Land at Roman's Farm, south of Mill Road, Burnham on Crouch

**Transport Objection on behalf of
local residents**

Railton TPC Ltd ref:	Burnham-on-Crouch 01E
Planning Inspectorate	Ref: N/A
Planning Authority	Ref: 25/00840/OUTM
Date:	January 2026
Author:	Bruce Bamber BSc MA MSc MCIHT

Plan 1: Alternative Routes to/from West

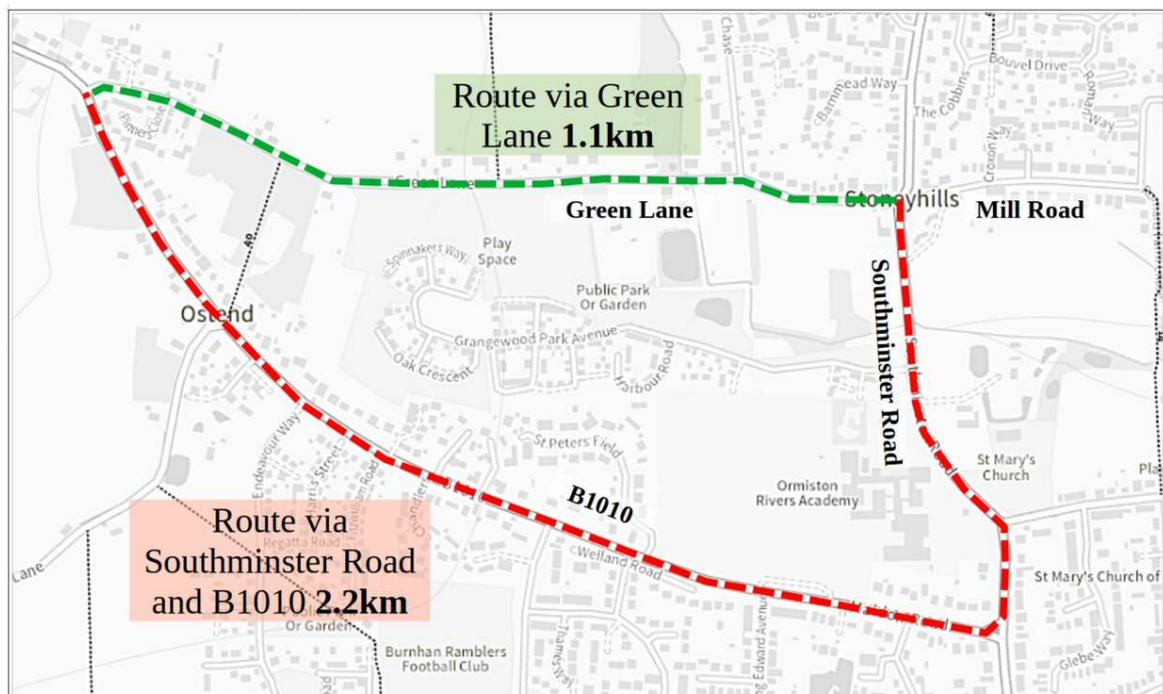
- 7.3 Drivers wishing to travel between the proposed site and areas to the west are able to do so by crossing between Mill Road and Green Lane rather than using the route comprising Southminster Road and the B1010. The route along Green Lane from the Southminster Road junction to the B1010 is 1.1km in length and the route via Southminster Road is 2.2km in length:

- 7.4 As explained in the previous section, the B1021/B1010 junction currently experiences delays, particularly in the PM peak hour and these delays are predicted to increase in the future assessment year (2030) and increase further with the addition of traffic associated with the proposed development. Green Lane therefore not only offers advantages in terms of a shorter journey distance but also allows delays at the B1021/B1010 junction to be bypassed. The time saving achieved by using the Green Lane route will increase as time goes on and with the addition of development traffic.

- 7.5 The applicant calculates that 52% of development traffic would be to and from the west via the B1010 Maldon Road (see Figure TF3). In the AM peak this constitutes 53 vehicle movements (Figure TF4) and in the PM peak, 49 vehicle movements.

- 7.6 The TA presents a sensitivity assessment whereby the level of development traffic using Green Lane mirrors the existing observed movements between Mill Road and Green Lane (i.e. assuming that future residents of Mill Road behave in the same way as existing residents of Mill Road). The TA concludes that if this were to happen it would *'not result in a material or adverse impact on the operation of Green Lane, or the junctions onto the B1010 Maldon Road and B1021 Southminster Road at either end'* (TA, para. 7.7.4). Although the applicant does not present percentage impacts, development traffic, in this situation, would constitute a 19% increase on Green Lane in the AM peak and a 28% increase in the PM peak.

- 7.7 It is suggested that an increase less than 30% falls below the 30% threshold for assessing transport environmental impact. This is incorrect since for highway links with high sensitivity, the threshold is 10%⁹. Green Lane is a sensitive link since it provides access to numerous properties, it does not have footways, it is unlit and narrow with blind bends.

Appendix 1: Proposed Southminster Road/Mill Road/Green Lane Junction (i-
Transport Drawing No. ITB19373-GA-009 rev.C)

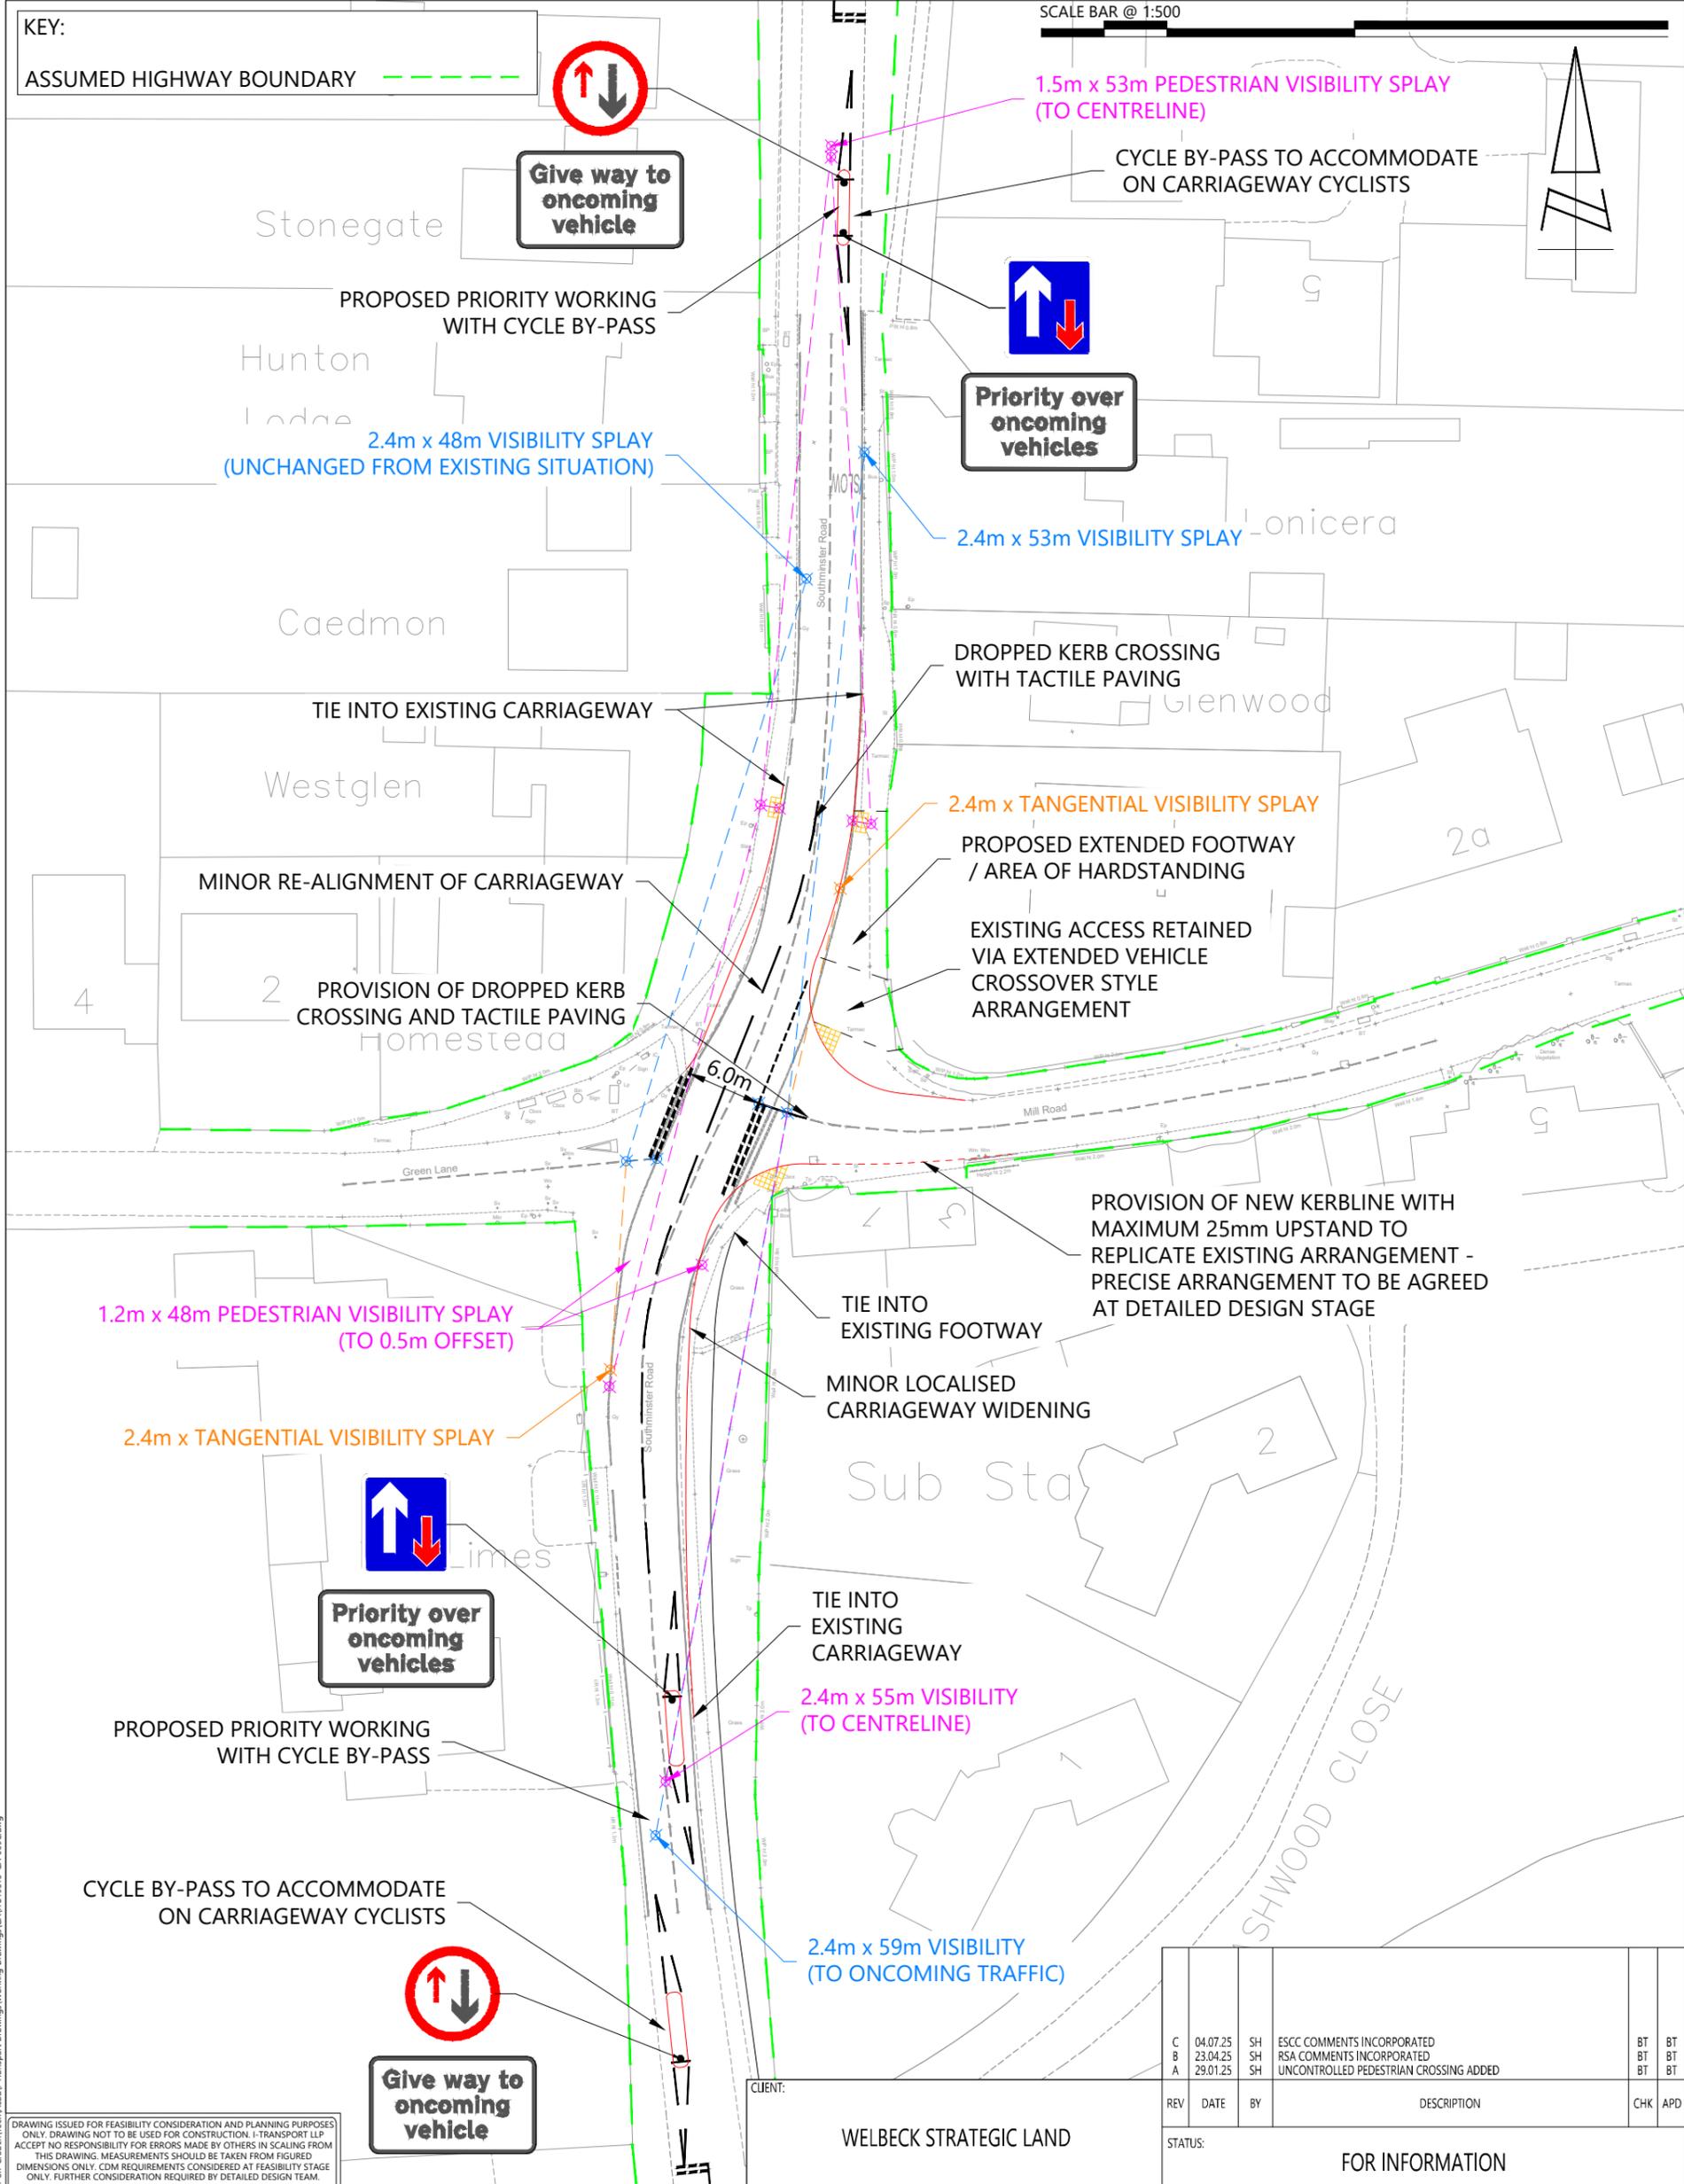
- 5.20 It is proposed to move the existing Mill Road give-way line to the west so that drivers waiting on Mill Road would have improved visibility to the left. This also has the effect of reducing the width of Southminster Road at the junction. It is proposed to adjust the alignment of Southminster Road in the vicinity of the junction by moving the carriageway north of the junction slightly to the west and moving the carriageway south of the junction slightly to the east. This has the effect of slightly 'smoothing out' the right-left bends in the road at this point. It is also proposed to introduce two road narrowings south of the junction to force vehicles to slow and give way and one road narrowing north of the junction. These traffic calming features would be entirely out of character with the remainder of Southminster Road.

- 5.21 The 'smoothing of the bends would normally lead to an increase in vehicle speeds along this section of Southminster Road. Roads are generally widened at bends to accommodate the swept paths of larger vehicles. In this instance it is proposed to **narrow** the road where vehicles are negotiating the two bends. In these respects the proposals are contrived and reflect the problem of trying to overcome the severe visibility constraint caused by the presence of the building south of the Mill Road give-way line.

- 5.23 The current proposals raise a number of concerns:
- There has been no assessment made of the potential of these features to lead to significant vehicle delays, particularly during peak hours and during the period when parents are picking up from the local secondary school just to the south;

- The proposals have the effect of narrowing the width of carriageway through the bends (the give-way line at Mill Road is moved into the carriageway and the give-

way line at Green Lane remains in the same location). Observations on site reveal that many vehicles, particularly approaching from the south, over-run the centre line of the road while negotiating the first right hand bend. The narrowing of the carriageway will exacerbate the risks of head-on or side swipe collisions in this area;

- The applicant presents swept paths of large vehicles passing each other on Southminster Road at the junction (Drawings ITB19373-GA-014, ITB19373-GA-016 and ITB19373-GA-017). These show large vehicles passing extremely close to each other, if not colliding, through the junction and over-running the edge of the carriageway south of Green Lane. The swept paths do not provide assurance that the narrowing of the carriageway through the junction will not lead to highway safety problems;

- The applicant shows sub-standard visibility to the left for vehicles emerging from Green Lane. A note on the drawing states that visibility is unchanged from the existing situation. This is not correct since the road narrowing to the north of the junction forces southbound vehicles to swerve onto the western side of the carriageway, effectively reducing the extent to which drivers waiting at the Green Lane give-way line are able to see approaching vehicles;

- South of the junction, vehicles approaching from the south are required to give way to vehicles approaching from the north at both the road narrowings. It is not clear whether a driver approaching from the south has sufficient forward visibility around the bend to be able to judge whether they can pass through the two narrowing before meeting an oncoming vehicle. If this visibility is not available, this could lead to head-on collisions as southbound drivers will expect priority.

5.24 It is concluded that the proposed amendments to the Southminster Road/Mill Road/Green Lane junction are contrived, do not appear to be safe for larger vehicles and may lack sufficient forward visibility for northbound drivers to avoid head-on conflicts close to the junction.
